**SSD 7317 - MODIFICATION 12 - RESPONSE TO SUBMISSIONS
AUSTRALIAN TECHNOLOGY PARK, EVELEIGH**

This Response to Submissions letter has been prepared by Ethos Urban on behalf of Mirvac Projects Pty Ltd (Mircac) to address submissions received during the notification period of the Section 4.55(1A) Modification 12 (MOD 12) to State Significant Development 7317 (SSD 7317) which relates to the development of a commercial campus at the Australian Technology Park, Eveleigh.

Figure 1 Marked up version of RMS Aerial 'X'

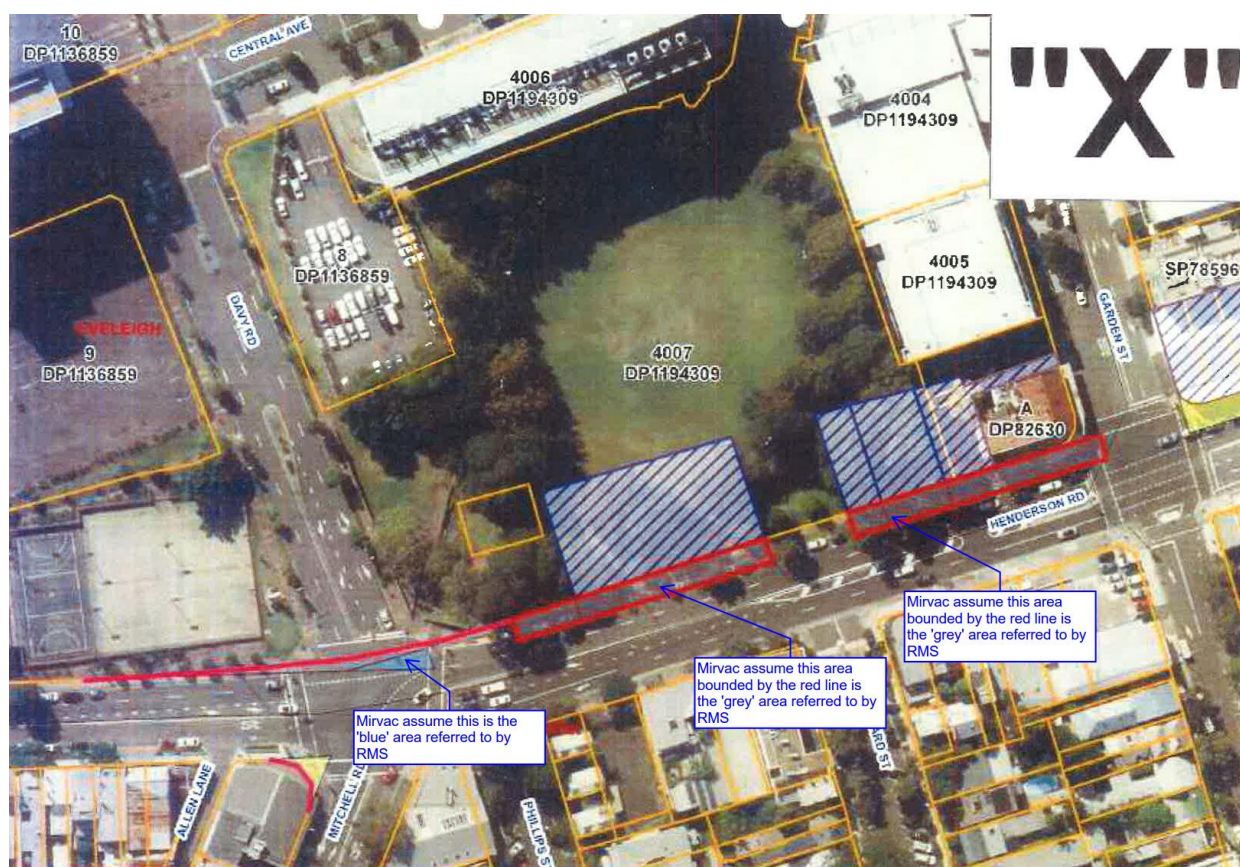
Roads and Maritime has previously acquired a strip of land for road along the Henderson Road frontage of the subject property, as shown by blue colour on the attached Aerial - "X". Roads and Maritime has also previously vested a strip of land as road along the Henderson Road frontage of the subject property, as shown by grey colour on the attached Aerial - Roads & Maritime Services has no other approved proposal that requires any part of the subject property for road purposes. Therefore there are no objections to the development proposal on property grounds provided all buildings and structures (including signage), together with any improvements integral to the future use of the site are wholly within the freehold property (unlimited in height or depth), along the Henderson Road boundary.

It is unclear in the RMS's Aerial 'X', which is the 'blue' area of land, and which is the 'grey' areas of land. On the basis of the blue and grey areas being those which are marked up in **Figure 1**, Mirvac confirms that these areas do not fall within Lot 4007 in DP 1197309 and therefore the proposed modifications do not impact these RMS blue and grey areas.

Figure 2 Extract of survey plan showing Transgrid Portal and access easement zone

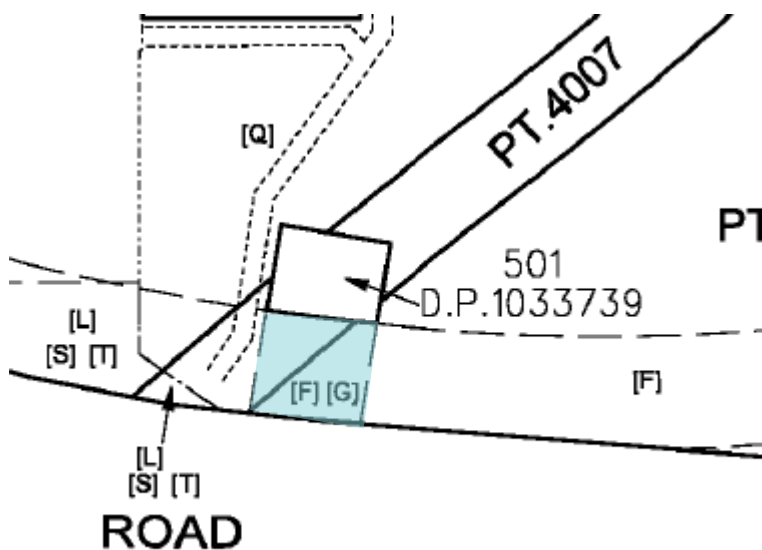
1. Transgrid must be able to maintain access to their portal in Australian Technology Park. Over the years there has been increasing vegetation growth narrowing access.
2. The proposed total signage S1.B is located in the access easement required for maintenance of the portal. It looks like it may impeded access/ egress and use of that area between the tree and the footpath for maintenance vehicle parking.
3. Transgrid requests that the maintenance access requirements and easement be considered as part of the masterplan.
4. The current access point to the tunnel portal being off Henderson Road (near Davy Road).
5. Vehicular travel to the tunnel portal is currently still possible within the grounds.

As identified in the modification application letter, the External Signage Strategy provided plans that identified the 'indicative signage locations' throughout the ATP precinct. Mirvac acknowledge that Transgrid require access to maintain their portal and will ensure that the signage totem S1.B or any other signage structures are located within Lot 4007 and not within the Transgrid portal (Lot 501 in DP1033739) or its easement zone, as highlighted in **Figure 2**.
